D2065 ARM

RELEASED
08.07.23.17

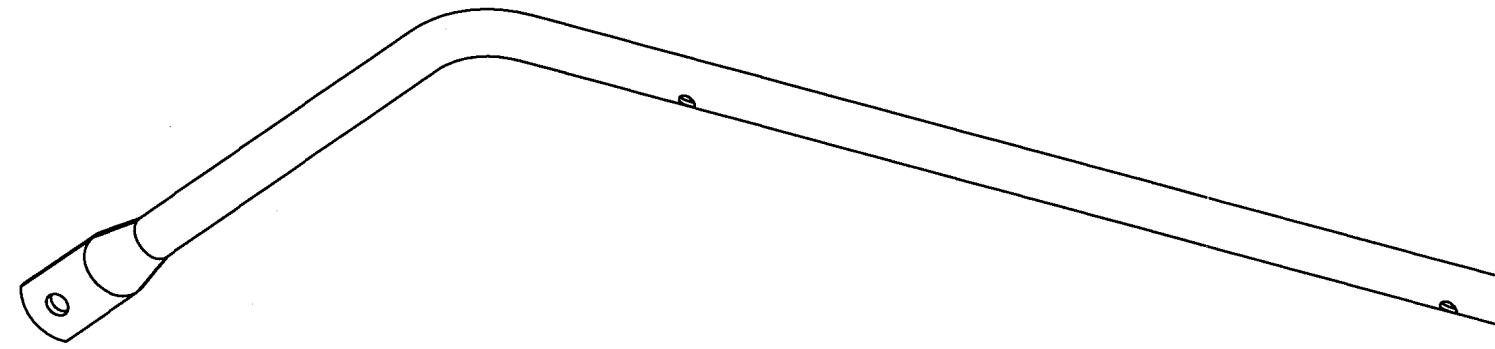
C	REDRAWN IN SOLIDWORKS; INCORPORATED REV. B1 (FINISH ADDED VIA HAND CHANGE) (ZN A6-2); ADD D2065 CUT LENGTH DETAIL FOR D2065 (ZN B3-2); ADD R1.50 DIMENSION (ZN D5-2); Ø 0.500 X 0.049 WALL WAS Ø 0.500 X 0.035 WALL (ZN A5-2); REASON: Ø 0.500 X 0.035 WALL TUBING USED ON D2010 IS CRACKING DURING SERVICE	PH	08.06.13
B	RE-DESIGN	BW	96.02.06
A	NEW ISSUE	BW	92.03.12
REV.	DESCRIPTION		
DESIGN	BW	DART AEROSPACE LTD HAWKESBURY, ONTARIO, CANADA	
DRAWN	PH		
CHECKED		DRAWING NO.	REV. C
MFG. APPR.		D2065	SHEET 1 OF 2
APPROVED		TITLE	SCALE
DE APPR.		ARM	NTS
DATE	08.06.13	COPYRIGHT © 1992 BY DART AEROSPACE LTD THIS DOCUMENT IS PRIVATE AND CONFIDENTIAL AND IS SUPPLIED ON THE EXPRESS CONDITION THAT IT IS NOT TO BE USED FOR ANY PURPOSE OR COPIED OR COMMUNICATED TO ANY OTHER PERSON WITHOUT WRITTEN PERMISSION FROM DART AEROSPACE LTD.
